TO: Dr. Jesse Bacon *JB*
FROM: Bret Highley *BH*
DATE: August 30, 2021
RE: Tier I 800 Student Elementary School *B*
BG 20-142, Change Order 07

Change Order

Re: Old Mill Elementary School
RFP 09 – Lower Level Beam Locations

REQUEST FOR PROPOSAL

Description:

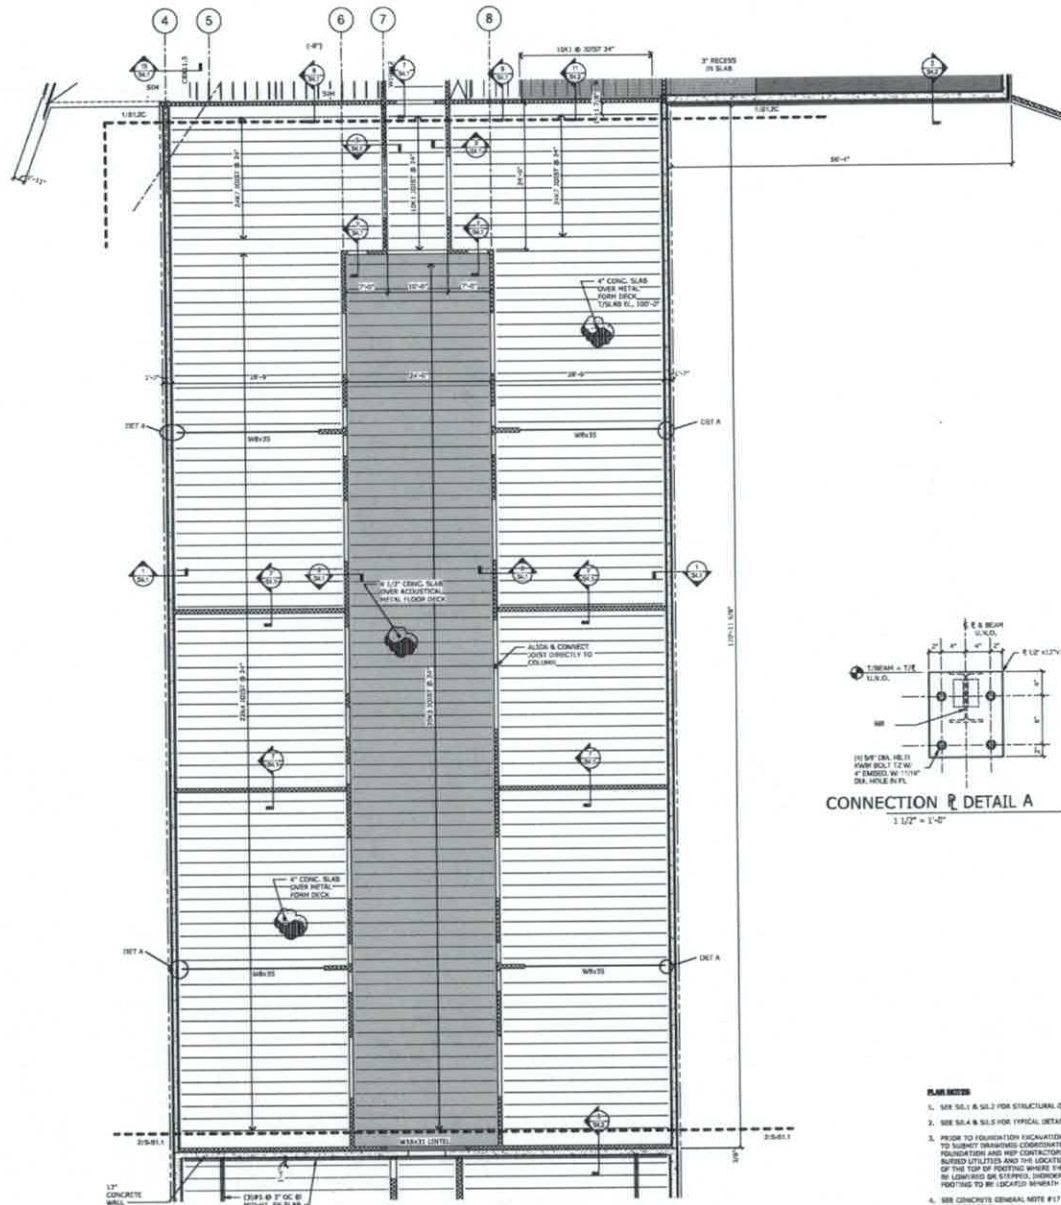
Provide price proposal for the following:

- Item 1:** Movable Partition manufacturer/installer to provide channel with 45-degree braced supports at four (4) movable partitions at Area D Lower Level. Partitions are located at Classrooms 101/103; 102/104; 105/107; 106/108

- Item 2:** Relocate two (2) W8x35 beams, already installed, to the underside of the floor deck at Classrooms 105/107 and 106/108. Provide steel plate connections at these locations as required.

- Item 3:** Relocate two (2) W8x35 beams, yet to be installed, to the underside of the floor deck at Classrooms 105/107 and 106/108. Provide steel plate connections at these locations as required.

- Item 4:** The four (4) W8x35 beams referenced in this RFP are included in the original project scope.
- Item 5:** Provide new steel plate connections as follows:

CONNECTION & DETAIL A
1/8\" = 1'-0"

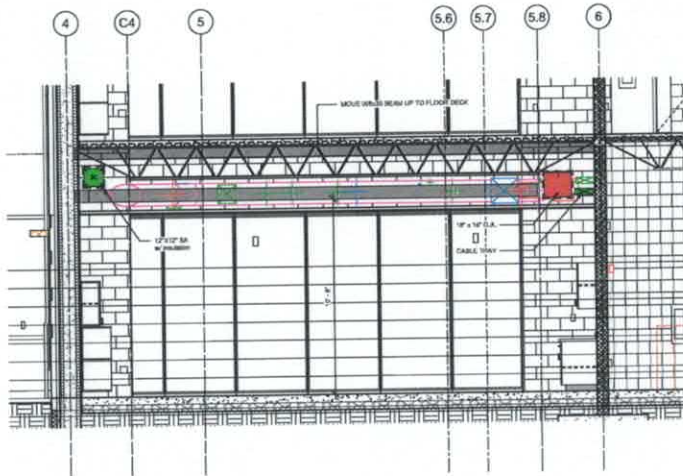
- Plate Connection at installed ICF Wall: See Detail "A" on drawing S1.2D, attached.
 - Plate Connection at installed CMU Wall: Re-use the existing embed plate at the new beam location. If the CMU wall is already installed, demolish a portion of wall to provide the new bearing.
